Subject: Industry Comments on Draft Regulatory Guide DG-1327, "Pressurized Water Reactor Control Rod Ejection and Boiling Water Reactor Control Rod Drop Accidents" (Federal Register 81FR83288, dated November 21, 2016 and 7590-01-P, dated January 26, 2017, Docket ID NRC-2016-0233)

Industry Response to Draft Regulatory Guide DG-1327

Figure 3.1 Proposed Replacement for Reference 2 Figure 3

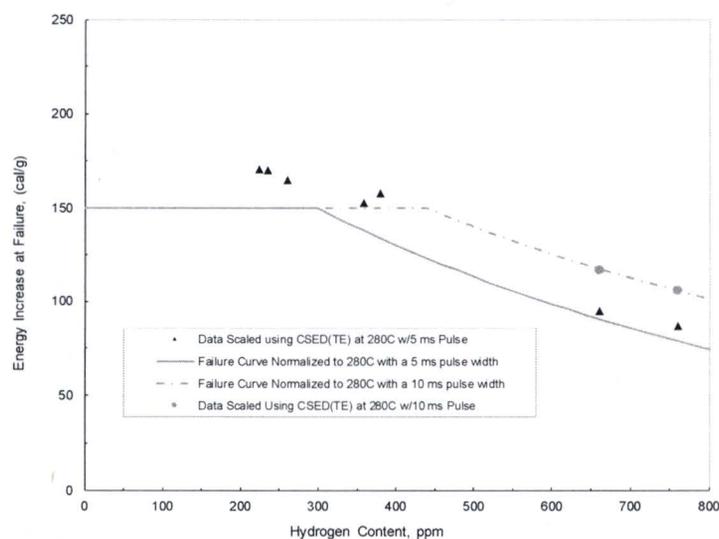
The PCMI cladding failure thresholds proposed by the NRC in Figure 3 (SRA cladding at high temperature; e.g. PWR Zr-4 application) and Figure 4 (RXA cladding at low temperature; e.g. BWR Zr-2 application) are based on NSRR test conditions that are atypical of LWR RIA events. EPRI research results expand the database of cladding performance during RIAs with a focus on the effects of pulse width and cladding temperature. Then the EPRI Falcon code uses the expanded database to develop proposed cladding failure thresholds based on the critical strain energy density concept that are applicable to LWR operating conditions during RIA events. These proposed cladding failure thresholds are more appropriate than the overly conservative DG-1327 failure thresholds.

Replace Reference 2 Figure 4 (RXA cladding at low temperature) with a constant PCMI cladding failure threshold of 150 Δ cal/g. Replace Reference 2 Figure 3 (SRA cladding at high temperature) with the 280°C and 10ms pulse width (blue dotted curve) on Figure 3.1:

Figure 3.15 EPRI Proposed PCMI Failure Threshold for Zr-4 Cladding PWR HZP Conditions (280°C) Based on the Falcon CSED(TE) Methodology

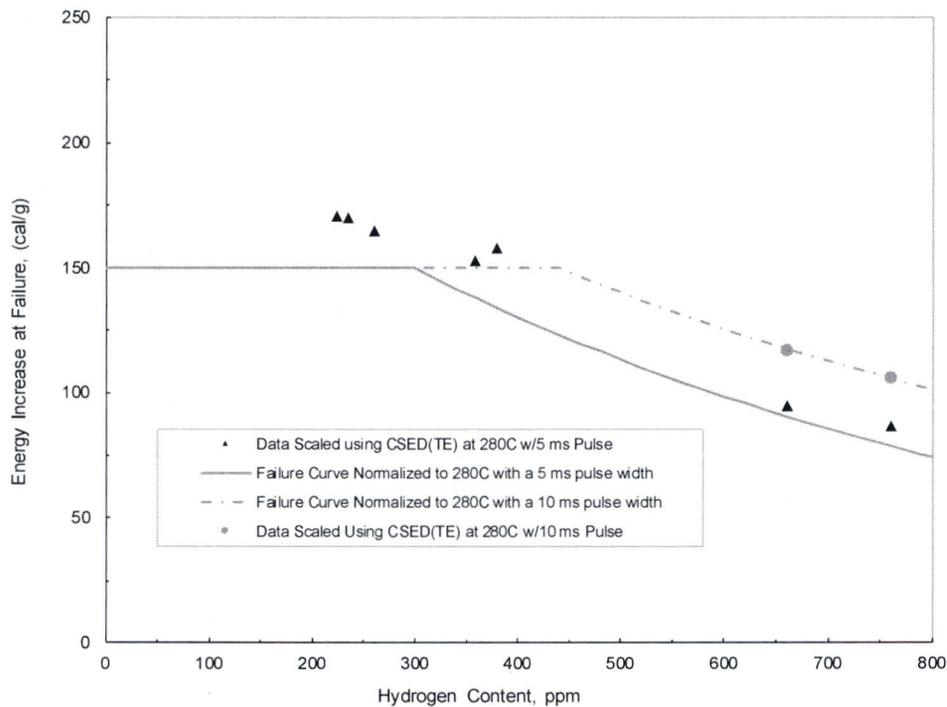
Figure 3.4 shows the PWR SRA cladding at 280°C is ductile (BS >2%) for hydrogen concentrations below ~420 ppm. An extrapolation of the slope from Figure 3.5 indicates that PWR SRA cladding at 280°C is ductile for pulse widths >15 msec. Based on CSNI/R(2010)1 the PWR CRE pulse width ranges from 25-65 msec at HZP initial conditions. Therefore, the combination of adjustments for temperature and pulse width indicate that PCMI failures will not occur for PWR SRA cladding at HZP RIA conditions.

The Falcon CSED(TE) predicted cladding failure limit for PWR SRA cladding at 280°C and assuming a 5 msec pulse width (NSRR), or a 10 msec pulse width (bounding PWR HZP REA) is shown in Figure 3.10. Falcon is then used to determine the Δ cal/g as a function of the PWR

NSRR failed cladding test hydrogen content values to reach the CSED(TE) limit for the 5 msec pulse width (NSRR), and for the 10 msec pulse width (PWR HZP REA).

The results are presented in Figure 3.15. The 10 msec data are then bounded by the selected limit line shown in Figure 3.15. The proposed limit line is a combination of the 150 Δ cal/g high-temperature cladding failure limit and the proposed PCMI limit for PWR SRA cladding at 280 °C. It is noted that application of the same approach for a typical PWR HZP REA 25 msec pulse width would show additional margin. Based on the test data presented, the adjustment of the data to a bounding PWR HZP REA pulse width, and the Falcon CSED analysis results, the PCMI cladding failure threshold for PWR SRA cladding at 280°C should be revised accordingly.

Figure 3.16 CWSRA cladding limit at CZP condition adjusted for loading rate effect.

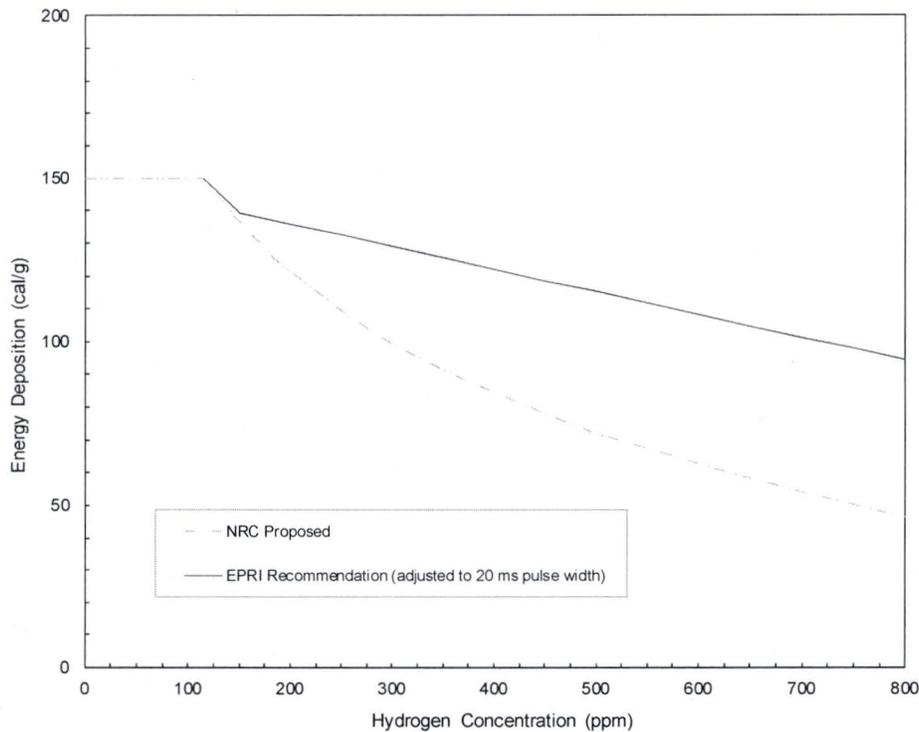
The PCMI cladding failure threshold proposed by the NRC in Figure 5 (SRA cladding at low temperature; e.g. BWR Zr-4 application) is based on a -18 Δ cal/g adjustment to the high temperature SRA cladding threshold. Based on insights from EPRI research into pulse width and temperature effects an alternate cladding failure threshold for SRA cladding at low temperature is proposed. The proposed cladding failure threshold is more appropriate than the overly conservative DG-1327 failure threshold.

PWR SRA cladding test data was obtained at room temperature and 280°C. Cladding of the same metallurgical condition (cold-worked SRA / CWSRA) is also used in BWR applications. Although the operating environments of the two reactor types are different, their impact on the cladding behavior is captured by their respective corrosion and hydrogen pickup models. The effects of pulse-width and temperature on cladding ductility observed with PWR SRA cladding would be applicable to SRA cladding in BWR application. Testing at intermediate temperatures was not conducted for the PWR SRA cladding, and therefore adjustment to the NSRR test results only considers the pulse-width effect. Test data indicates SRA cladding at room

temperature to have a stronger pulse width dependence (0.1% BS/msec) than RXA cladding (0.055% BS/msec), but because of the limited test data pulse width range, the lower slope room temperature RXA cladding pulse width dependence is used to adjust the NSRR test data assuming a conservative 20 msec pulse width. The proposed limit for SRA cladding at BWR CZP conditions is shown in Figure 3.16.

Replace Figure 5 (SRA cladding at high temperature) with the red line shown in Figure 3.16.
